Shoalhaven Traffic Committee

Meeting Date: Tuesday, 09 March, 2021

TC21.18 Parking Restrictions - Bolong Road - Bomaderry (PN 3641)

TC21.19 Parking Restrictions - Tallyan Point Road - Basin View (PN 3642)

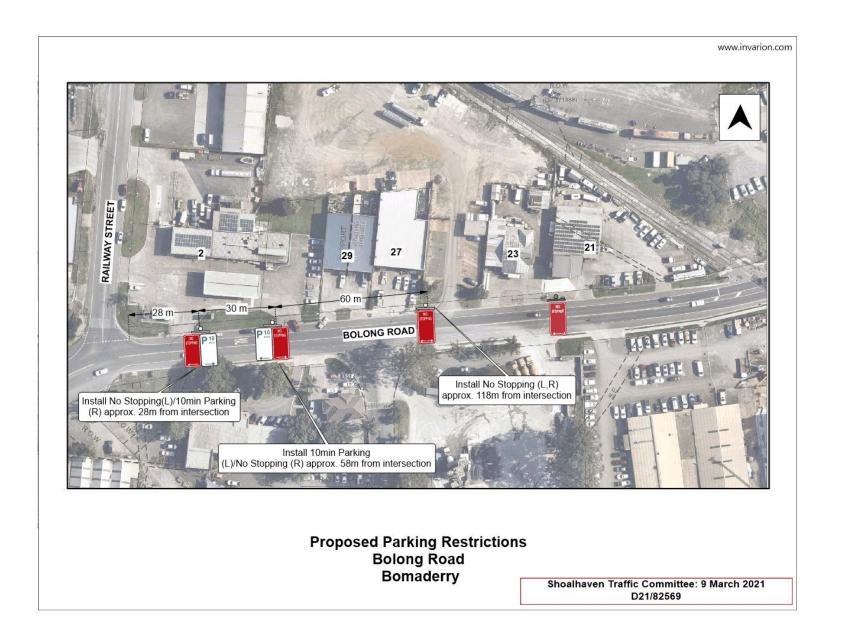
- Option A (retention of 30m of unrestricted parking to the east) will result result in potential sight distance obstructions and risks to road safety due to the longer term stays of vehicles within this space.
- Option B (reduction of unrestricted parking zone by 6m) will improve sight distance for vehicles exiting the easternmost service station's driveway and improve road safety.
- Option C (implementation of 30m 10-minute timed parking zone) will facilitate brief stops without compromising sight distance over longer periods of time. This would still compromise sight distance during shorter stays.

Option B – reducing the unrestricted, all-day 30m parking zone to a 24m unrestricted, all day parking zone and providing a 6m 'No Stopping' zone west of the easternmost service station's driveway is recommended as the safest option of the three.
